Project IEEE 802.16 Broadband Wireless Access Working Group <<http://ieee802.org/16>>

Title OFDM preamble Ad Hoc interim voting results for Downlink

Abstract This document contains ad hoc voting results for the OFDM preamble design for the 802.16a system.

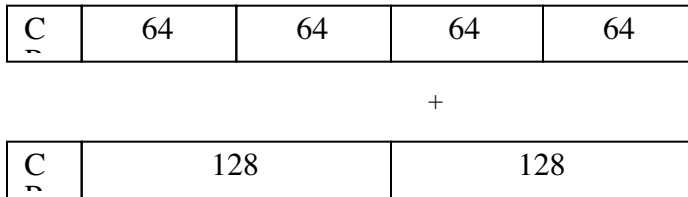
Insert at: Page 178, Line 43
Section 8.3.5.3.3.9 Preamble Structure

For OFDM Licensed bands, the TDD and FDD downlink preamble structure should be

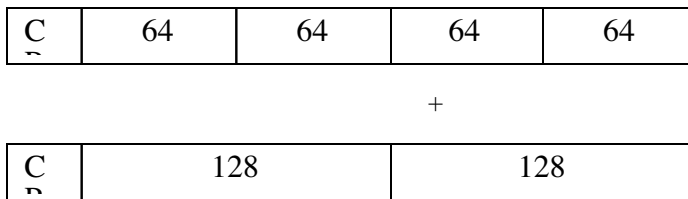
Delete lines 21-65 on page 206 and delete lines 1-46 on page 207 and replace with the following. Insert the following text under section 8.3.5.4.4.2 Downlink Preambles , Page 206, Line 20

For OFDM unlicensed bands, the TDD downlink preamble should have the following structure
